## **Access Compliance Report Public Rights-of-Way** (Curb Ramps)

Intersection ID: 23437 Main Street: MOSS\_RD Cross Street: S\_TRYON\_ST Location: NE

**Overall Compliance: No ADA ID: 8ACD512BDDAD** Ramp Type: Perp Initial Pass/Fail: Fail Severity Score: 13.75

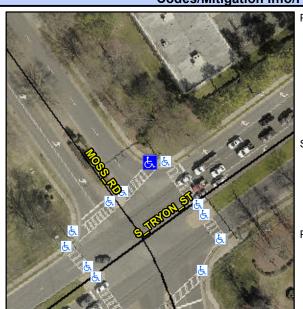
Possible Solutions:					
Remove & Replace Entire Ramp.					
Surveyor Notes:					
N/A					
PROW/ADA:					
Not Found, R304.2.2					
Not Found, R304.2.2

Field Measurements/Component Compliance								
Compl	iance Description	Data	Comp	liance Description	Data			
N/A	Ramp Length (in)	53.0	No	Ramp Slope (%)	9.1			
Yes	Ramp Width (in)	48.0	Yes Ramp XSlope (%)		2.5			
N/A	Flare Type LT	N/A	N/A Flare Type RT		N/A			
N/A	Flare Slope LT (%)	N/A	N/A Flare Slope RT (%)		N/A			
N/A	Flare Traversable LT?	N/A	N/A Flare Traversable RT?		N/A			
N/A	Landing Length (in)	N/A	N/A	DWS Provided?	N/A			
N/A	Landing Width (in)	N/A	N/A	DWS Contrast?	N/A			
N/A	Landing Slope (%)	N/A	N/A	DWS Length (in)	N/A			
N/A	Landing X Slope (%)	N/A	N/A	DWS Full Width?	N/A			
N/A	Landing Curb? (Y/N)	N/A	N/A	DWS Offset (in)	N/A			
N/A	Shared Landing?	N/A						
N/A	Gutter Ponding?	N/A	N/A	Gutter Slope (%)	N/A			
N/A	Gutter Lip Ht (in)	N/A	N/A	Gutter X Slope (%)	N/A			
N/A	Painted X Walk1?	Yes	N/A	Painted X Walk2?	N/A			
	X Walk 1 Direction	To W		X Walk 2 Direction	N/A			
N/A	X Walk 1 Width (in)	118.0	N/A	X Walk 2 Width (in)	N/A
